SUBJECT: NEW ORCHARD FARM ELEMENTARY SCHOOL
ORCHARD FARM R-V SCHOOL DISTRICT
ST. CHARLES, MISSOURI
PROJECT # 23-09B

ADDENDUM NO. 1 PROJECT 23-09B
ORCHARD FARM R-V SCHOOL DISTRICT
NEW ELEMENTARY SCHOOL
ST. CHARLES, MISSOURI JULY 23, 2024

The drawings and specifications are hereby supplemented and amended to include the following particulars:

PROJ. NO.	23-09B
DATE ISSUED	
	07-02-2024
DATE REVISION	
1	07/23/24 ADDENDUM #1
DRAWN BY	Author
CHECKED BY	CW
SHEET NO.	
	M3.2
	SD: 4

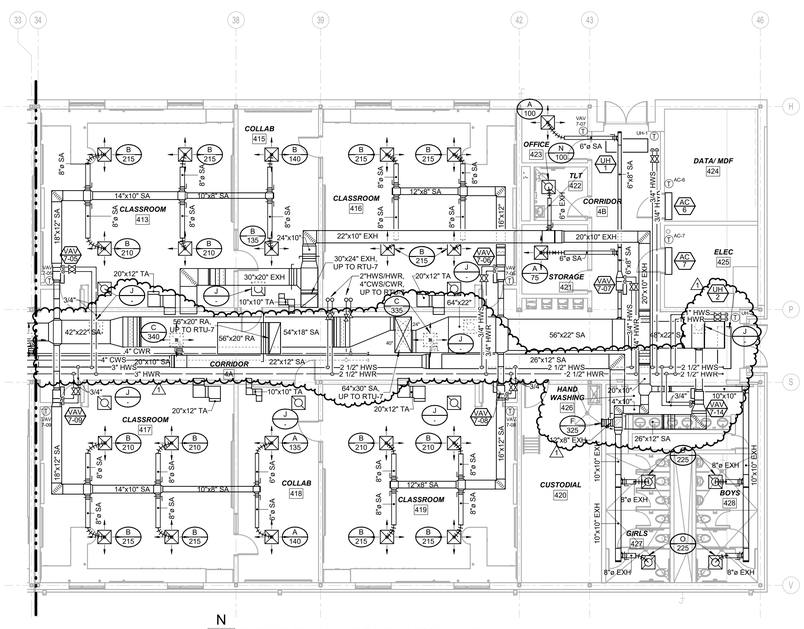
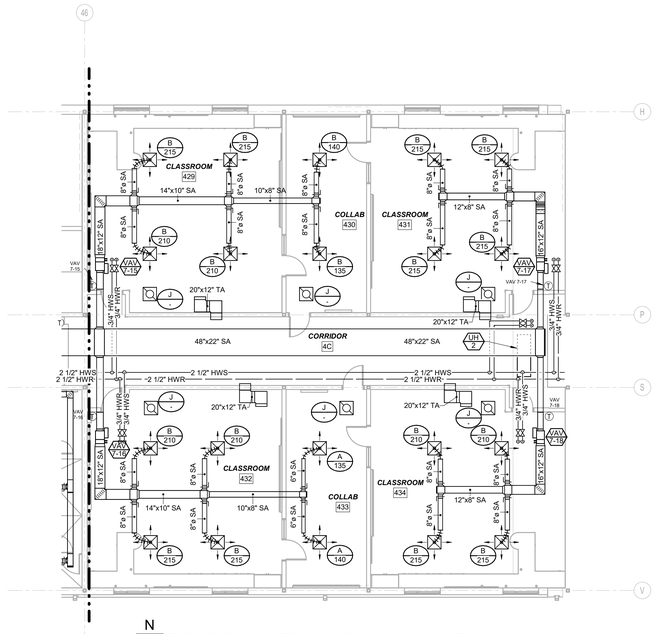
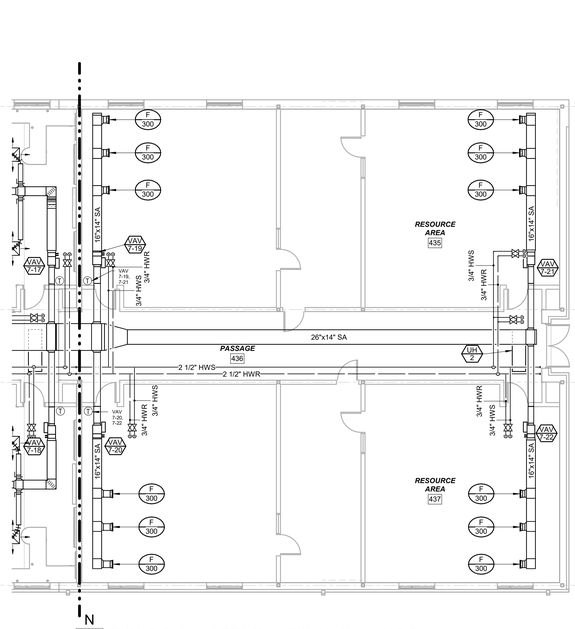
A. **"ADD"** Heating water piping to RTU-2.
B. **"ADD"** RLF-2 ductwork.
C. **"ADD"** Storm Shelter control damper locations.
D. **"ADD"** Exhaust duct to Custodial 300.

M3.4
SD: 5

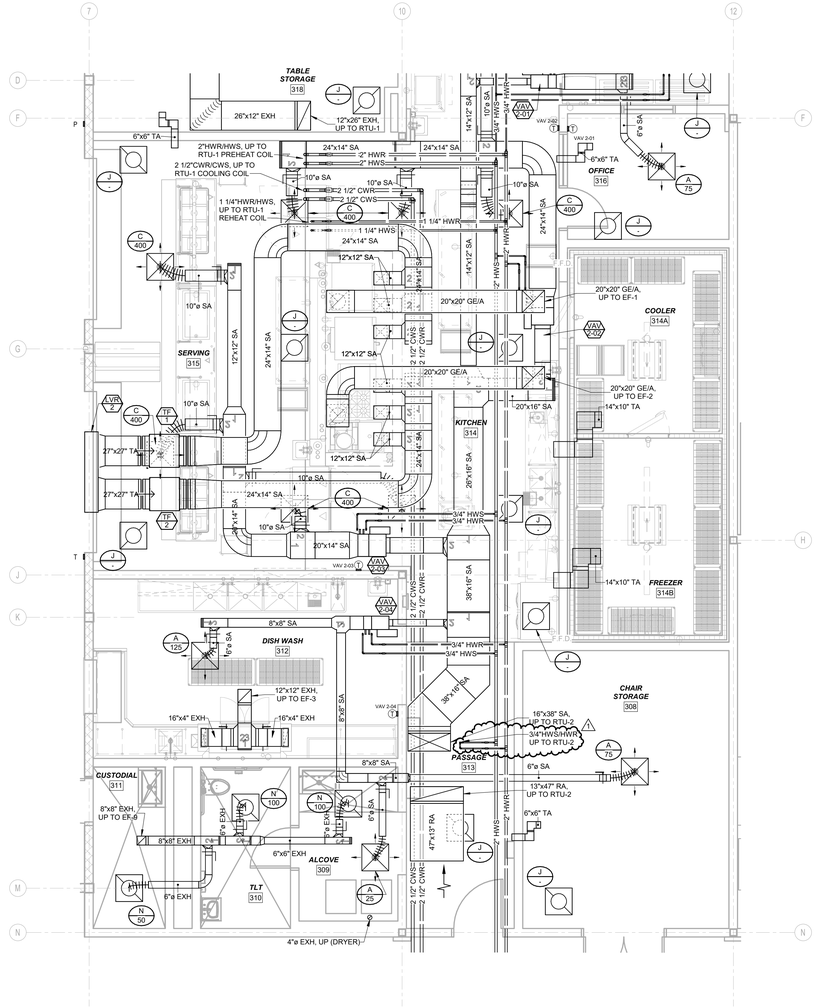
A. **"ADD"** Ductwork for VAV 7-14.

DRAWN BY	Author
CHECKED BY	CW
SHEET NO.	P1.2
	SD: 8

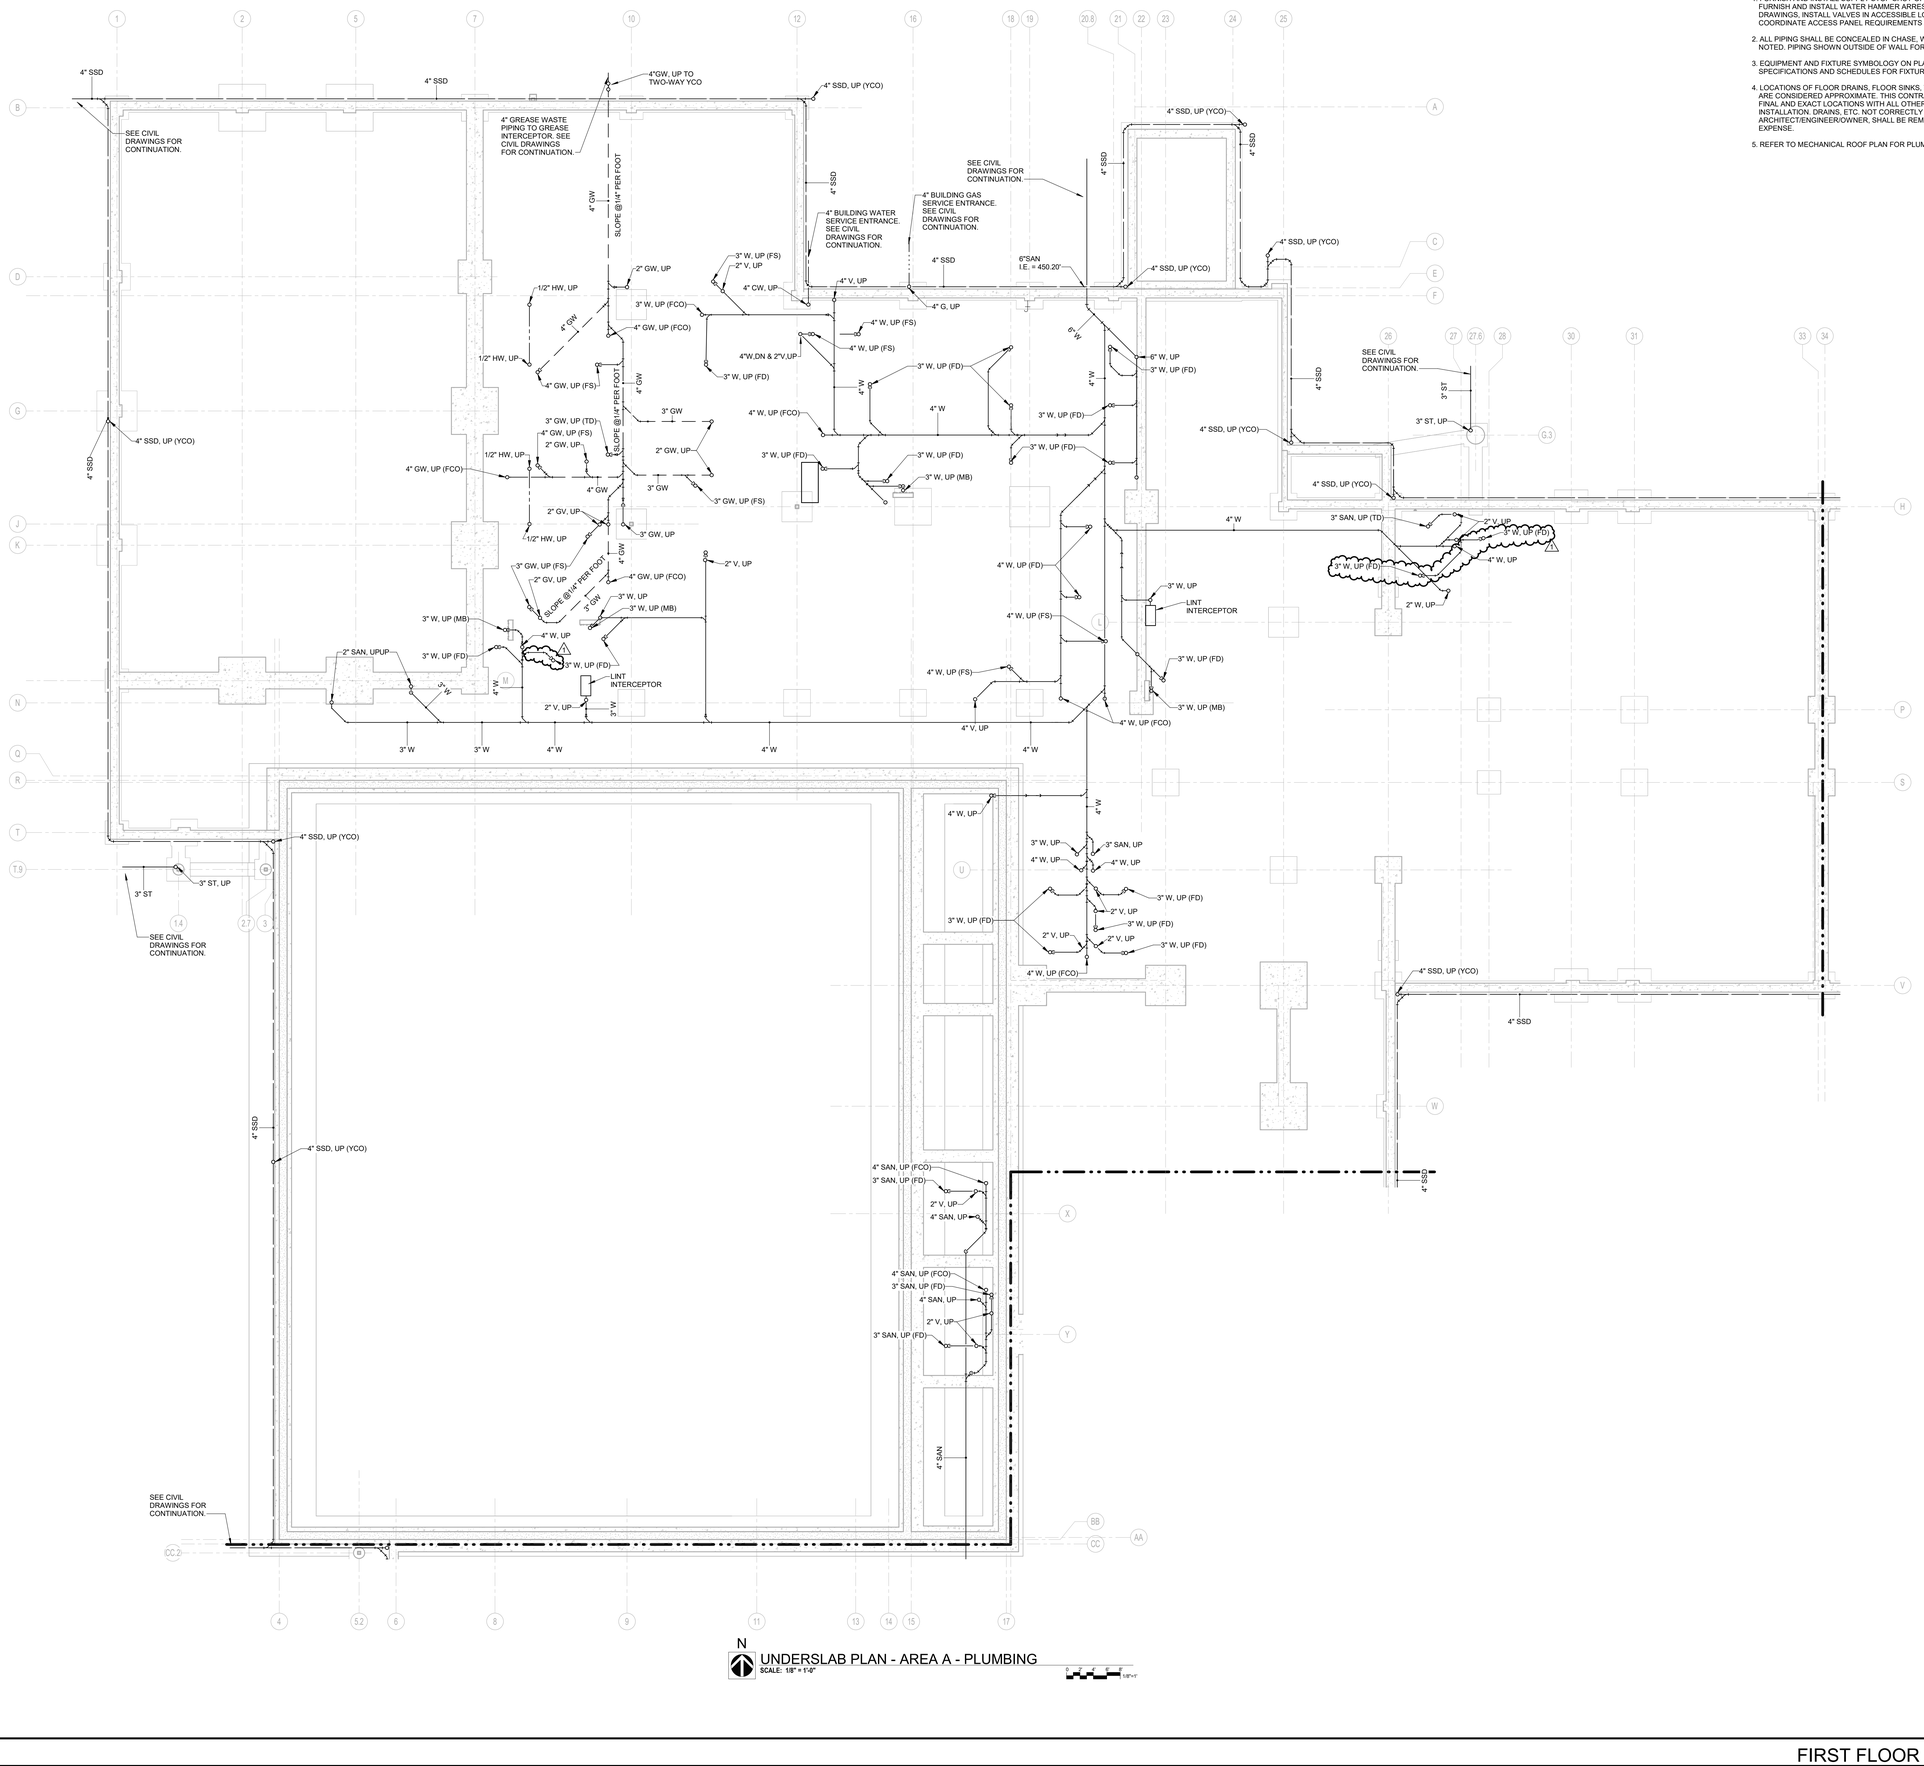
A. **"REVISE"** Underslab piping up to floor drain.

P1.5
SD: 11

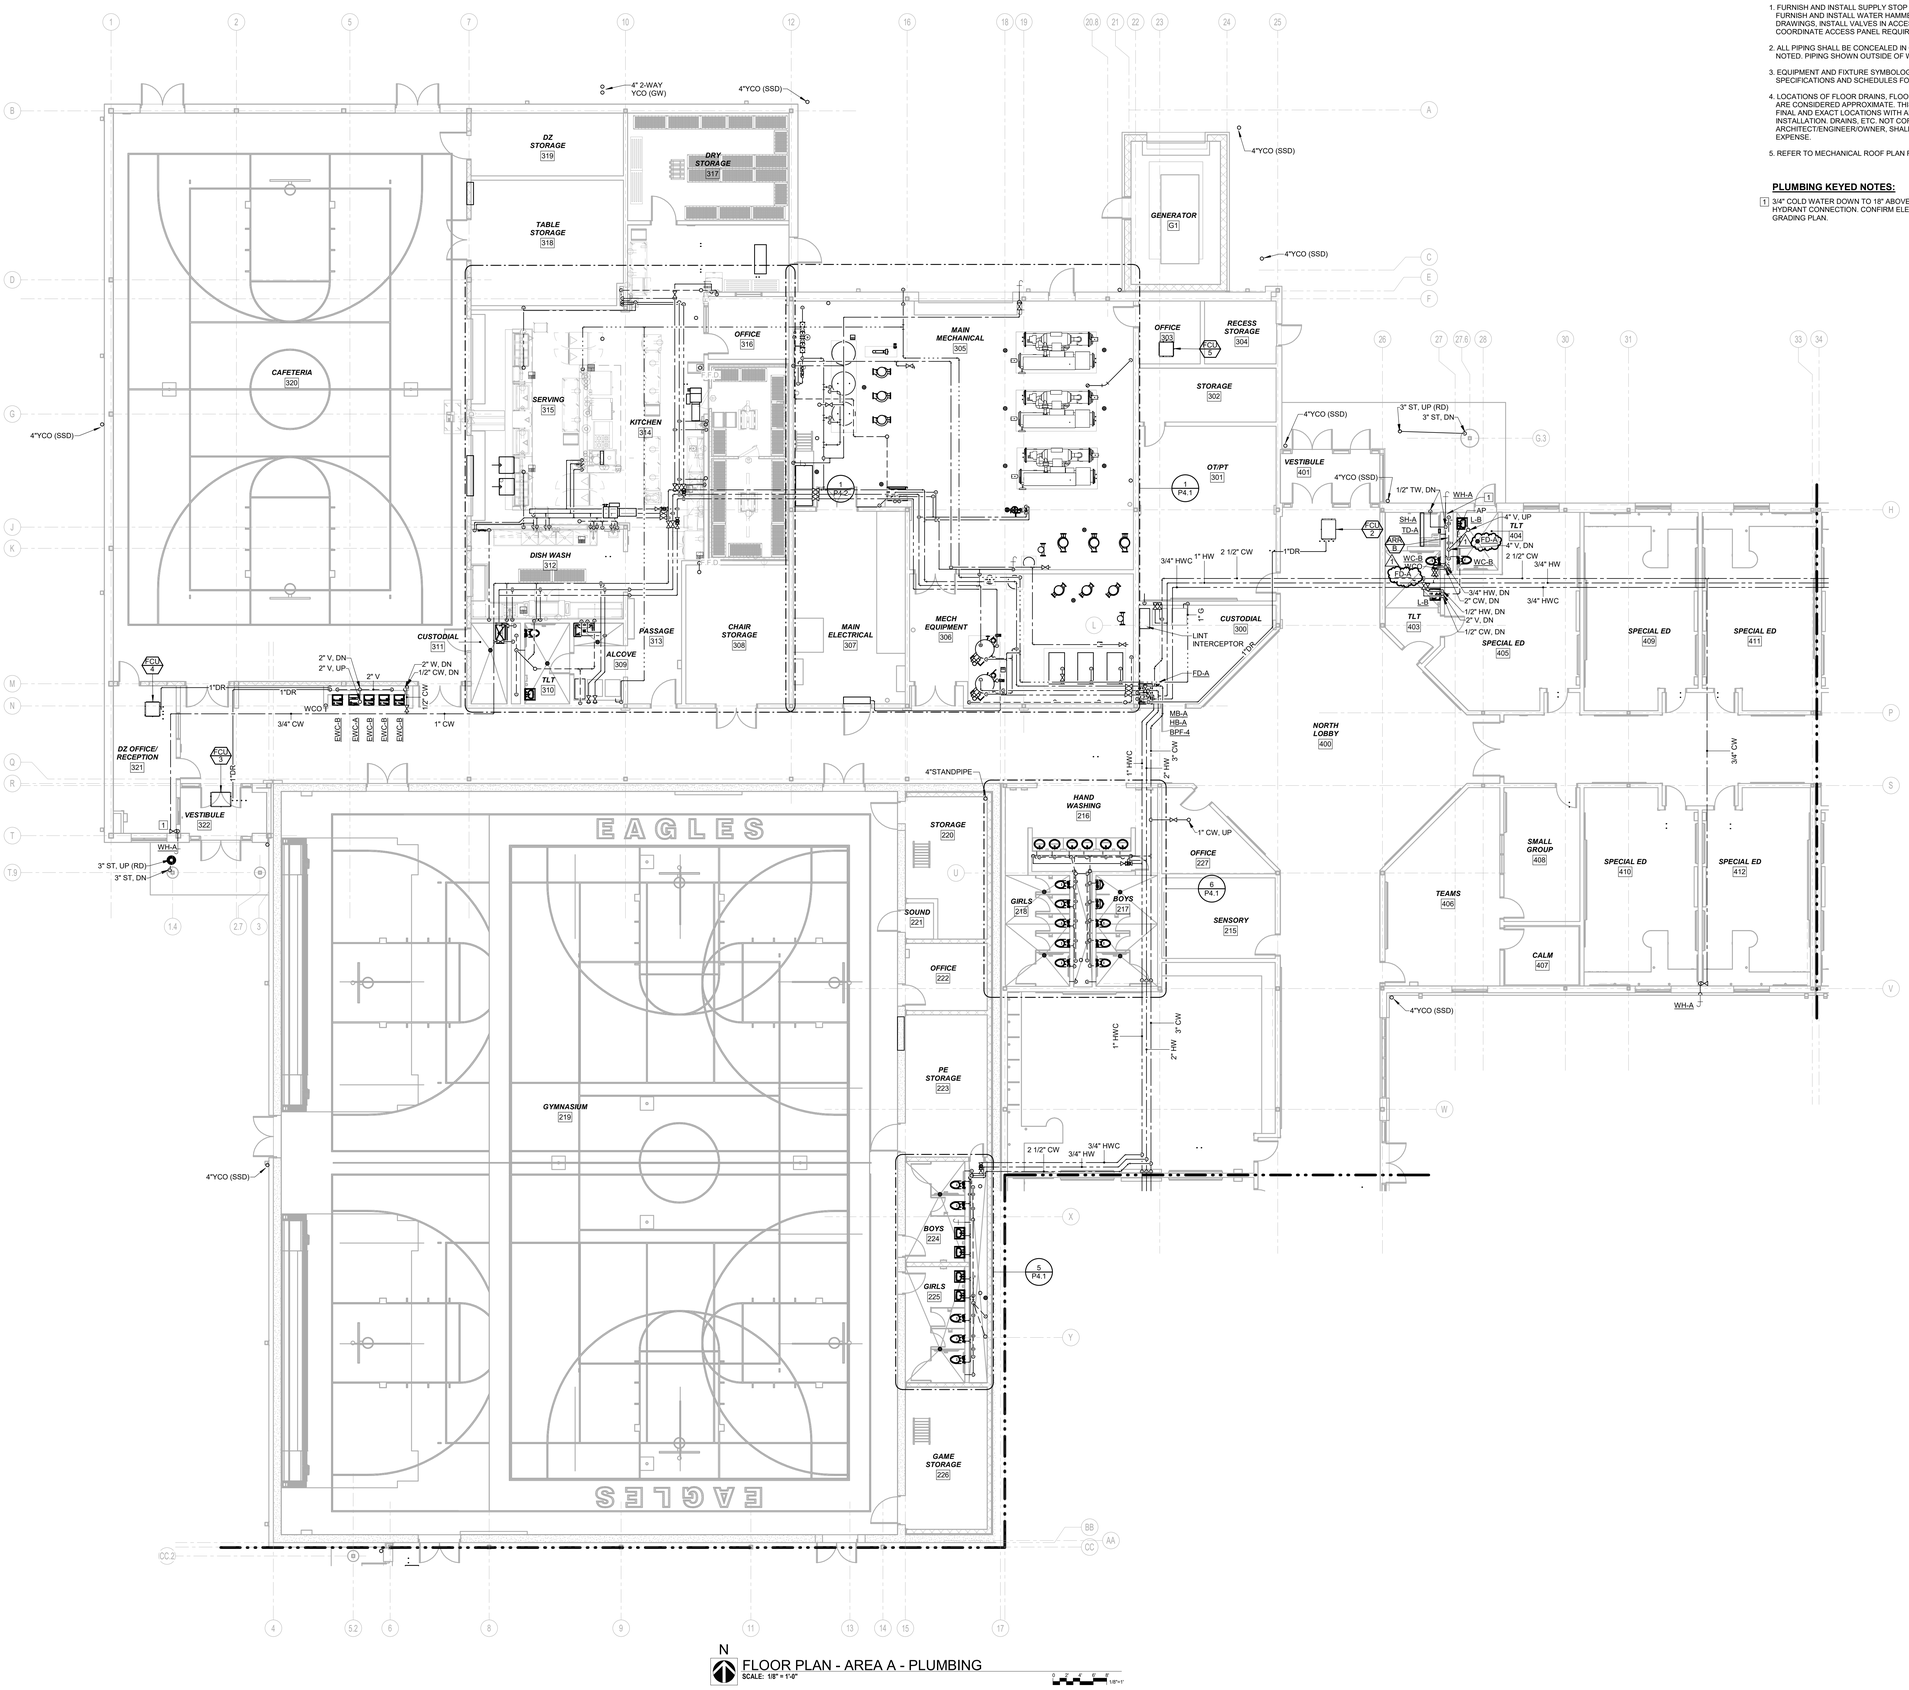
A. **"REVISE"** Underslab piping up to floor drain.
